Location:	Lake Merritt BART Transit-Oriented Development (TOD) at 51 9th Street (Block 1) and 107 8th Street (Block 2).
Assessor's Parcel Number(s):	APNs: 001 016900100 and 001 017100200.
Proposal:	1. Amend the Conditions of Approval to allow for phased submittal of the PX and PZ Permit for Phase I of development. 2. Amend the Tentative Tract Map to create a vertical division of the Paseo resulting in a subterranean parcel containing the BART tunnel.
Applicant:	East Bay Asian Local Development Corporation (EBALDC)
Contact Person/ Phone Number:	James Perez /510-512-2444
Owner:	San Francisco Bay Area Rapid Transit District (BART)
Case File Number:	PLN20108-R01
Planning Permits Required:	Revision to existing entitlements for Planned Urban Development (PUD), the Phase I Horizontal Final Development Plan (FDP and Tentative Tract Map).
General Plan:	Central Business District (CBD)
Zoning:	D-LM-2, D-LM-4, Height Area LM-275

CITY OF OAKLAND PLANNING COMMISSION

Case File: PLN20108-RO1
Applicant: James Perez
Address: 51 9th St & 107 8th St
Base Zones: D-LM-2, D-LM-4
Combining Zones: S-13, S-14
Height Area: LM-275

REVISED VESTING TENTATIVE TRACT MAP NO. 8560 (BLOCK 1) AND 8577 (BLOCK 2) TR

LAKE MERRITT BART DEVELOPMENT (BLOCK 1)
REVISED VESTING TENTATIVE TRACT MAP NO. 8560
PROPOSED PARCELIZATION PLAN (BLOCK 1)
 ALAMEDA COUNTY CALIFORNIA
 CITY OF OAKLAND

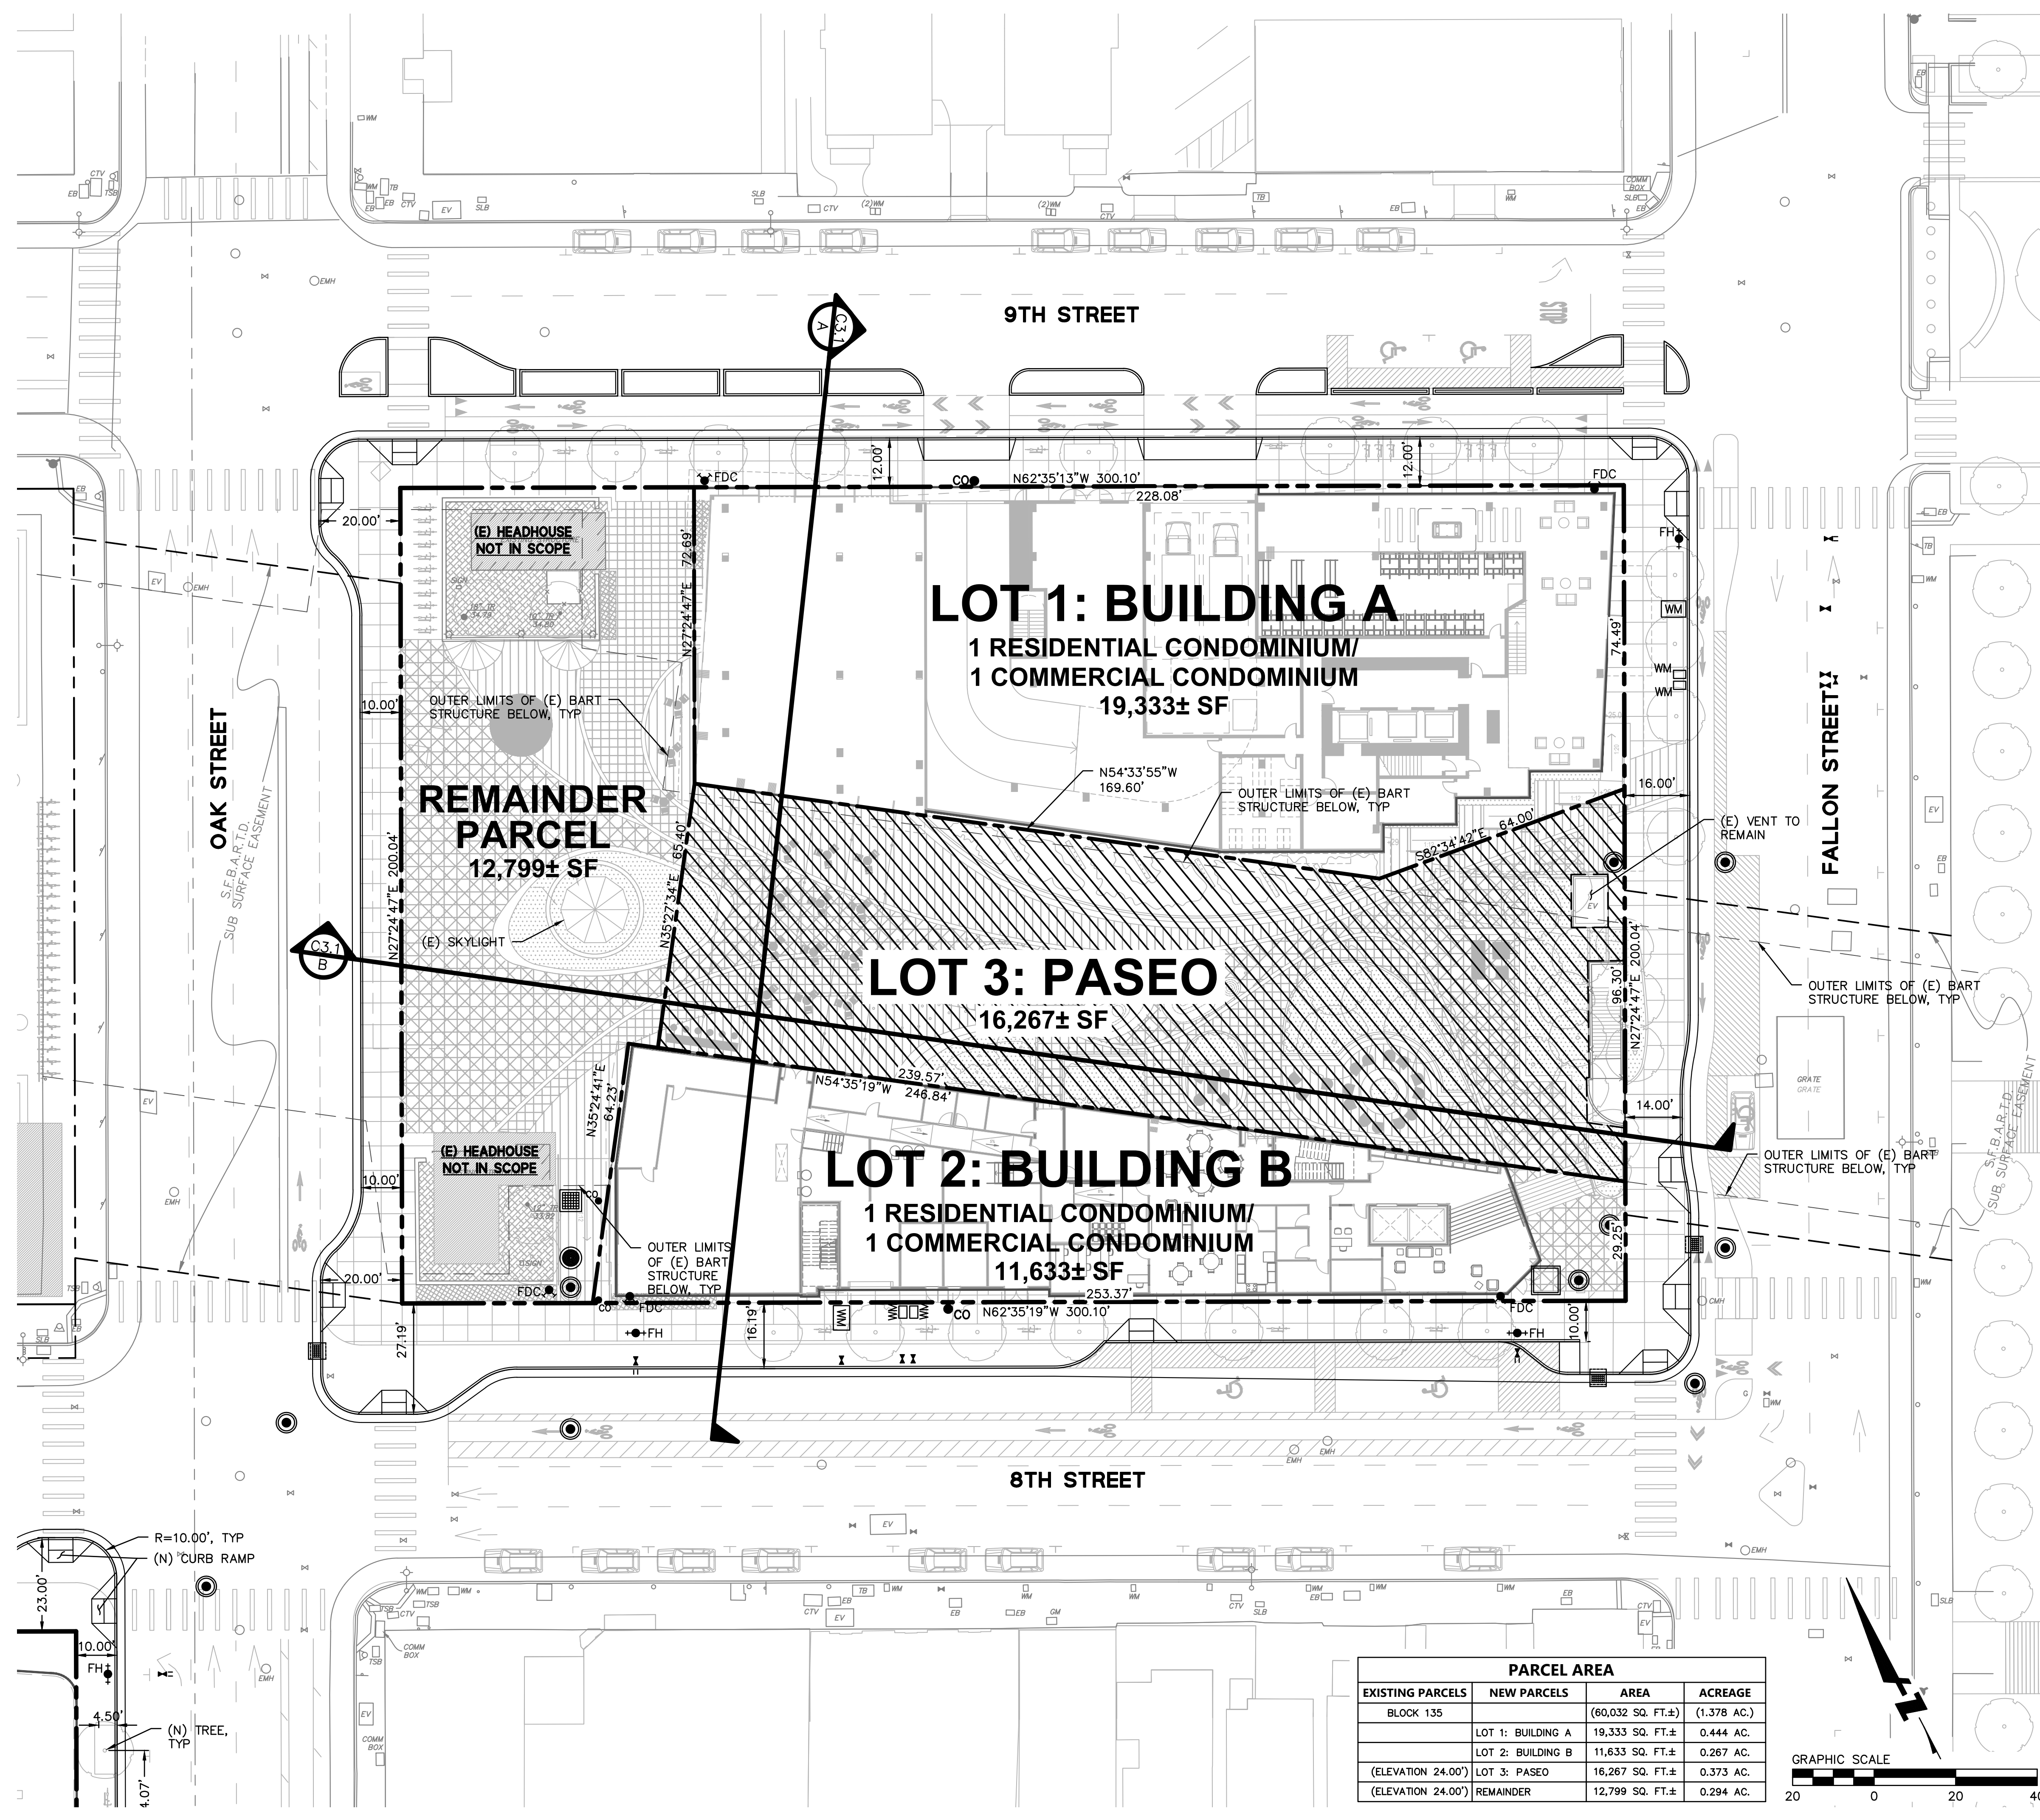
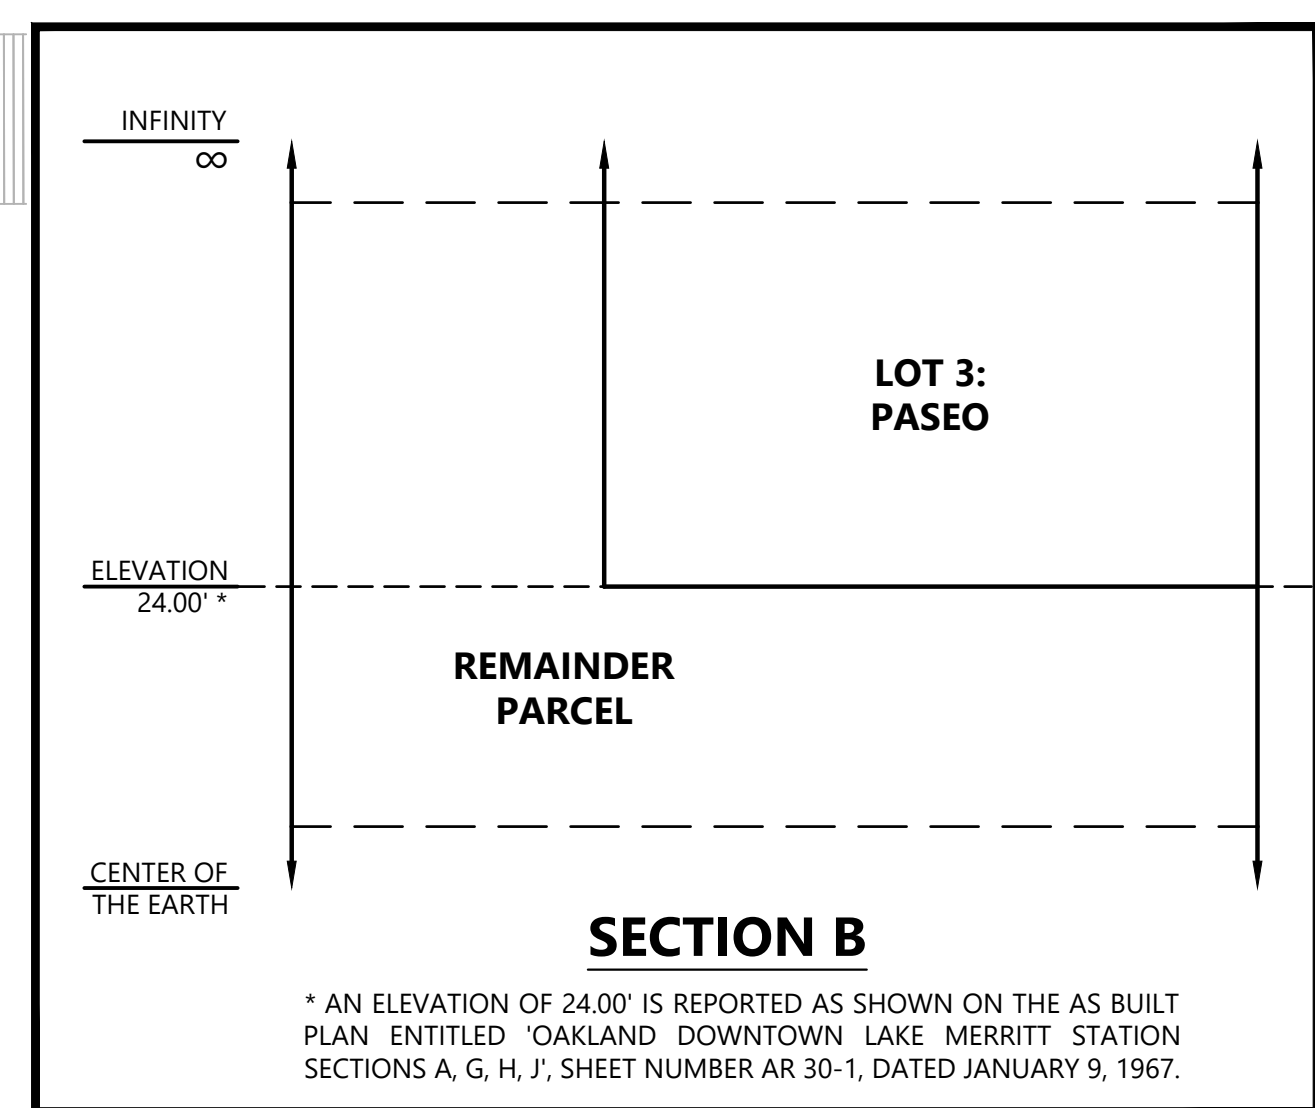
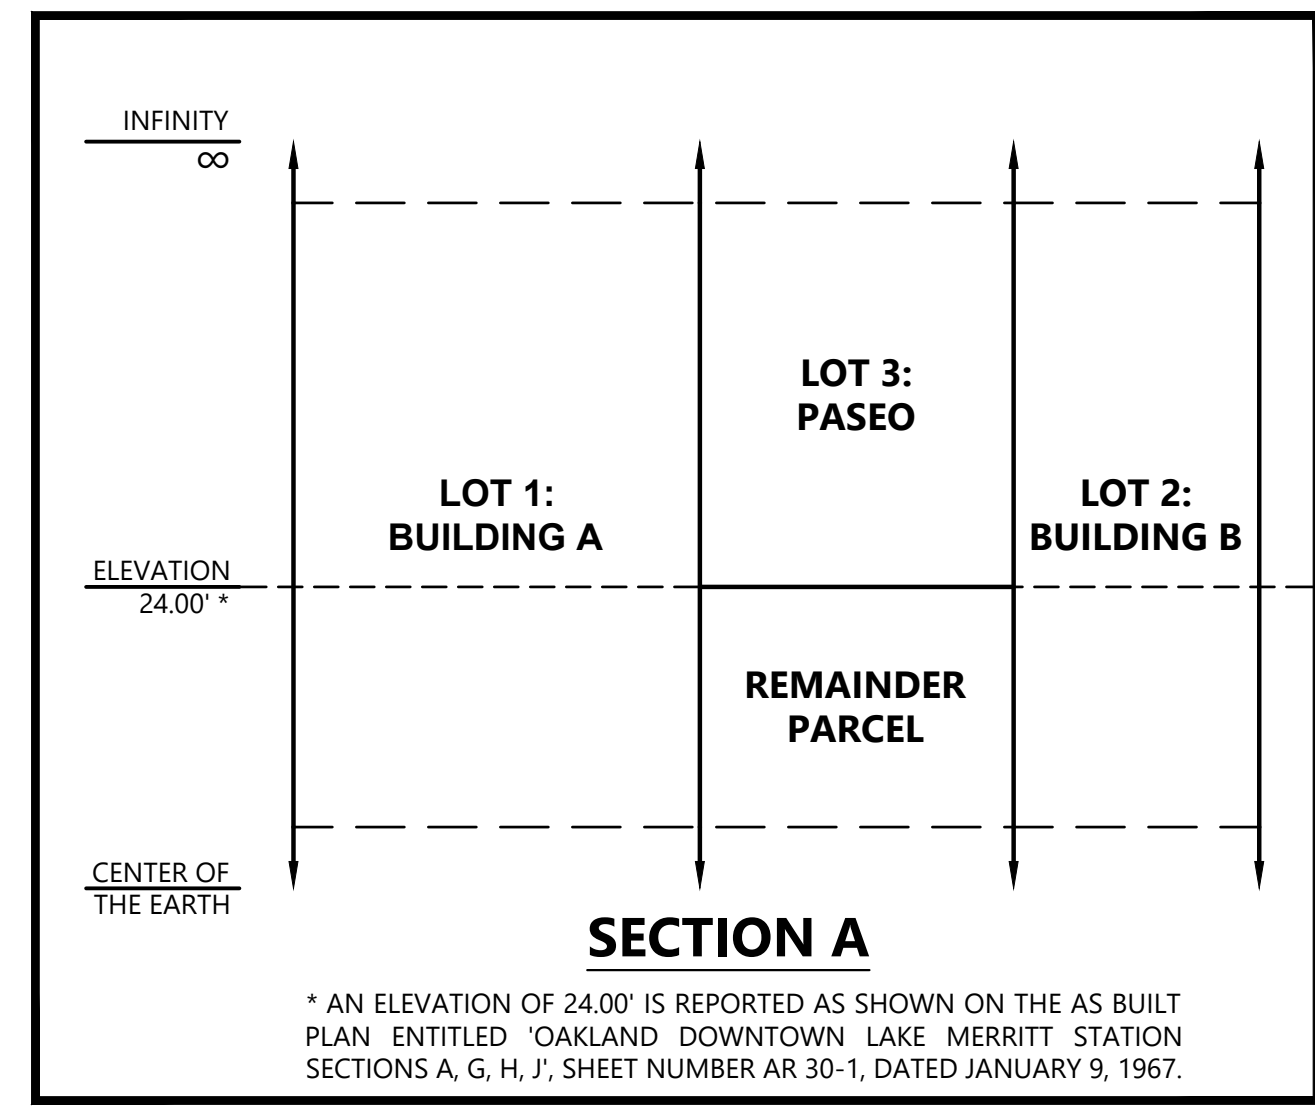
2. Amend the Tentative Tract Map (TTM) to create a vertical subdivision of the Paseo (Parcel 3).

The Paseo is located above a portion of BART's subway tunnel system. Typically, a parcel of land includes rights to all air space above the surface and all land below the surface. However, in this case BART requires sole control over the portion of the property (subterranean) in which the tunnel is located. BART requested that the property leased to the developer be subdivided to create one parcel for the Paseo and a second (subterranean) parcel containing the tunnel and the subsurface below the paseo that would be retained by BART. The revised map shows a 24' height to the remainder parcel where it abuts Lot 3, the Paseo, effectively creating the proposed vertical subdivision. **Attachment C** includes the amended Tentative Tract Map.

3. Amend the Tentative Tract Map (TTM) to conform lot lines and parcel sizes with the lot configuration approved by the Planning Commission during FDP review.

After approval of the TTM as part of the PUD review, BART further analyzed existing site conditions and determined that the lot configurations on the tentative map resulted in BART substructures projecting into the future residential properties. BART requested adjustment of the FDP map to eliminate this projection. The change to the map resulted in a reconfiguration between Lots 1, 2 and 3 and the remainder parcel. The change in the parcel configuration is shown in **Attachment D**, which compares the PUD map and the FDP version. The FDP was approved with this correction, however the TTM itself was not amended concurrently so the approved TTM still has the configuration shown on the PUD map. The proposed TTM shows the conformed lot lines and parcel sizes and as amended would resolve this conflict.

Date	03/20/2024	No.	1
Scale	1" = 20'	Revisions TO PARCEL GEOMETRIES AND AREAS:	
Design	DFS	VERTICAL SUBDIVISION DEFINED	
Drawn	DFS		
Approved SRN			
Job No	201910110
